# City of Sandy

### Planning Commission Meeting

**Meeting Date:** Monday, April 22, 2019

**C2.0**  
 SITE PLAN

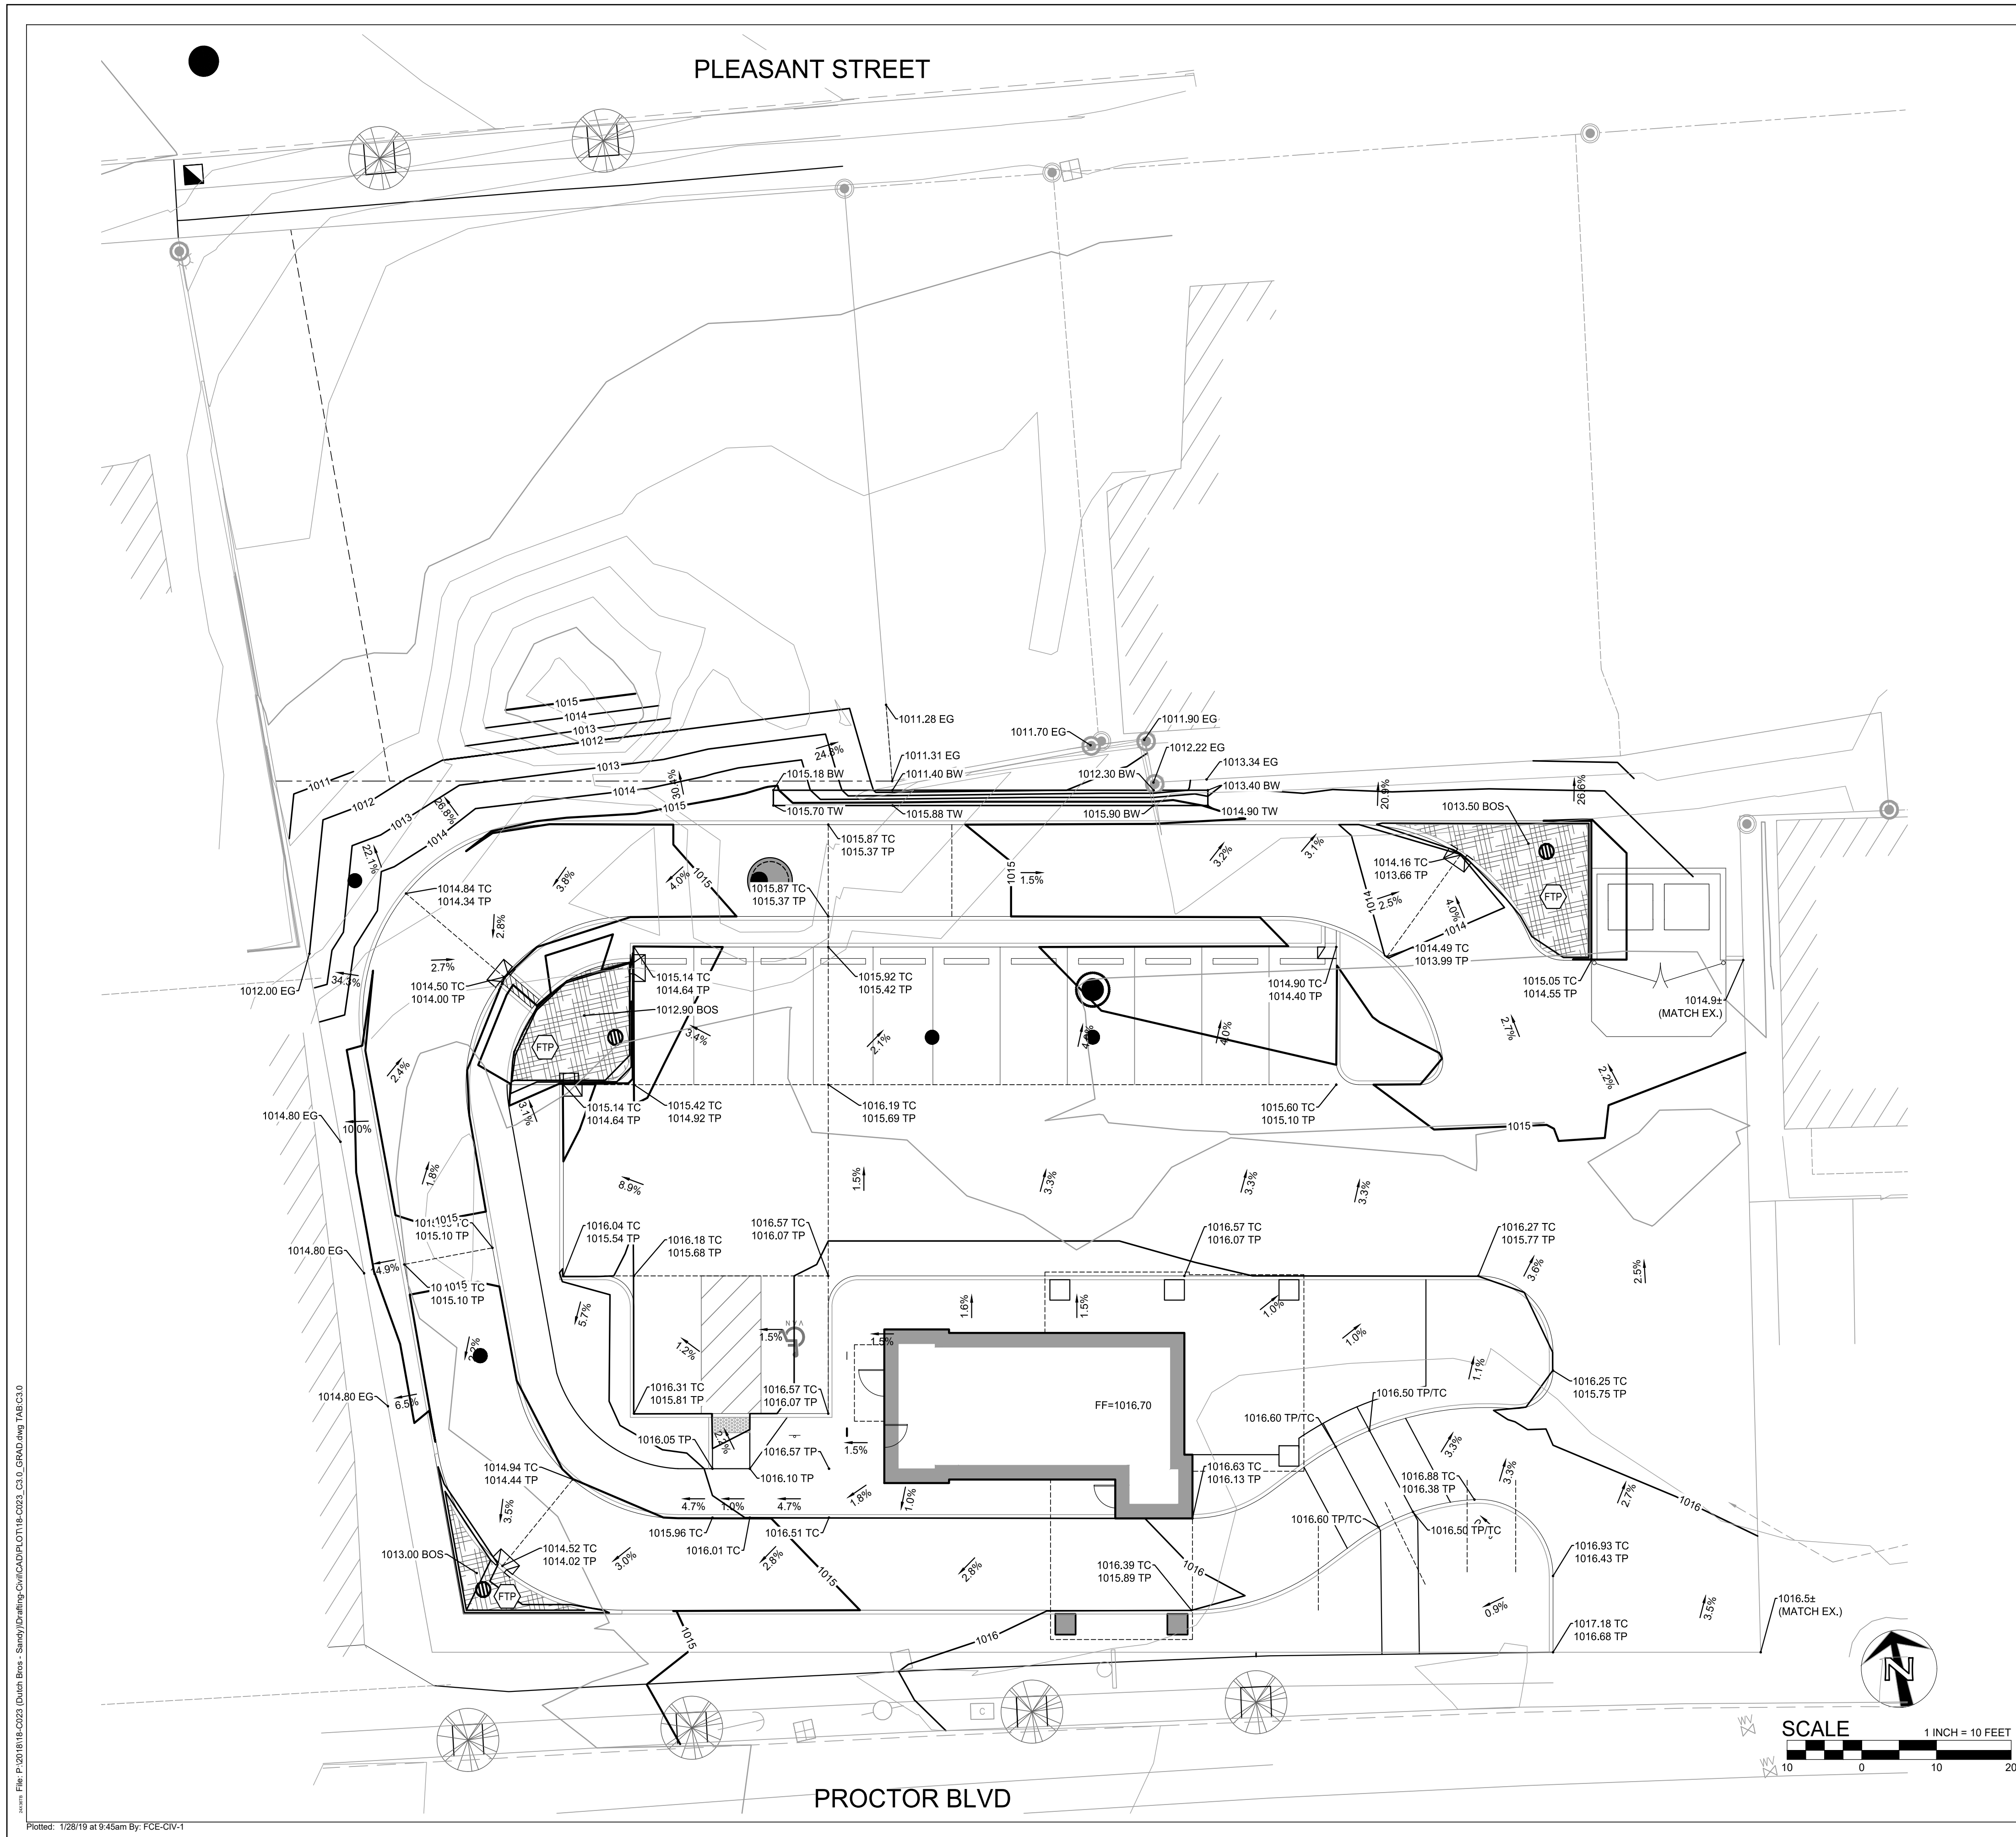
**RESPONSE:** This section of code was analyzed by reviewing the submitted site plan (Exhibit I, Sheet C2.0). The proposed ground covering for the parking area is an approved material, asphalt. The site does not propose any parallel parking spaces; however, the proposal provides a total of 13, 90-degree parking spaces. The 90-degree parking spaces measure 9 feet wide by 18 feet deep while the single ADA parking space measures 9 feet wide by 18 feet deep with an 8-foot-wide by 18 feet deep dedicated stripped area adjacent to the parking stall. **The proposal includes one ADA parking space that is 9 foot wide by 18 feet deep with an adjacent 8 foot by 18 stripped access aisle and ramp to meet Oregon Revised Statute (ORS) 447.233.**

**RESPONSE:** This section of code was analyzed by reviewing the submitted site plan (Exhibit I, Sheet C2.0). The proposed ground covering for the parking area is an approved material, asphalt. The site does not propose any parallel parking spaces; however, the proposal provides a total of 13, 90-degree parking spaces. The 90-degree parking spaces measure 9 feet wide by 18 feet deep while the single ADA parking space measures 9 feet wide by 18 feet deep with an 8-foot-wide by 18 feet deep dedicated stripped area adjacent to the parking stall. **The proposal includes one ADA parking space that is 9 foot wide by 18 feet deep with an adjacent 8 foot by 18 stripped access aisle and ramp to meet Oregon Revise Statue (ORS) 447.233.**

**COMMENT: Drive and aisle widths are detailed on the Architectural Enlarged Site Plan (Sheet A1.1) as well as the Civil Site Plan (Sheet C2.0). This project meets this requirement.**

**C3.0**  
 GRADING PLAN

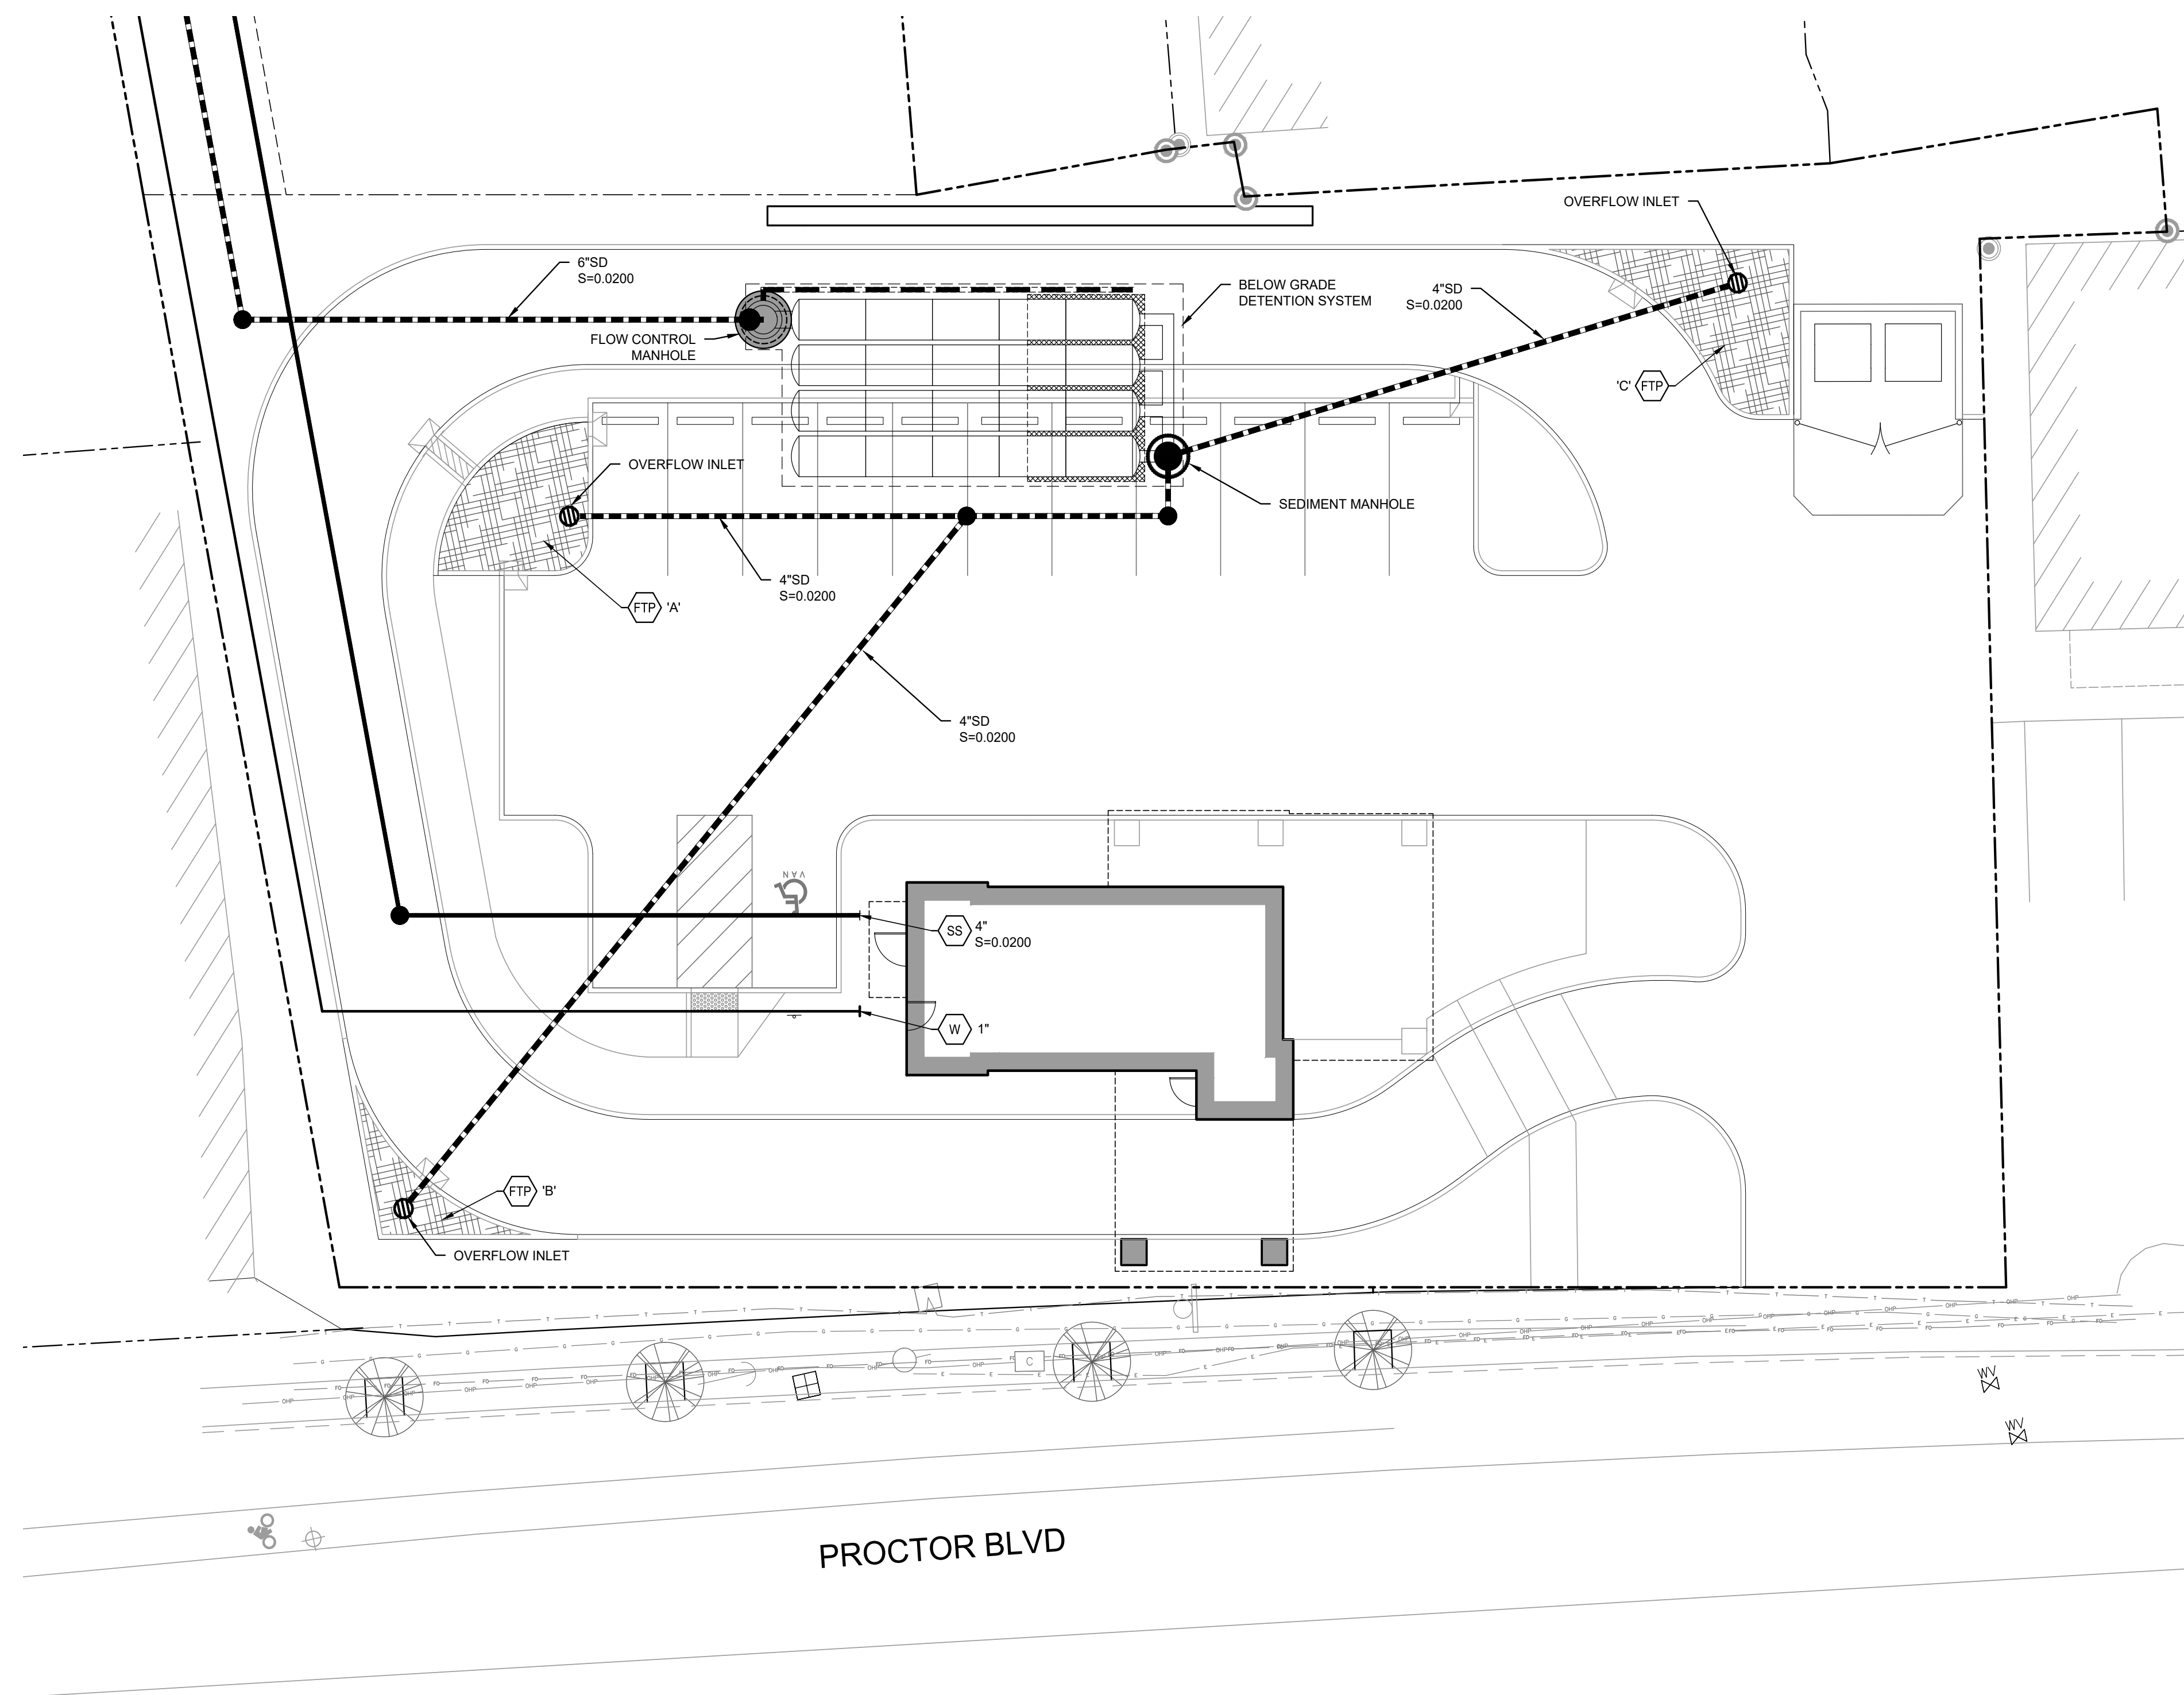
**COMMENT:** This project meets this requirement - see Grading Plan, Sheet C3.0 for slope indications.
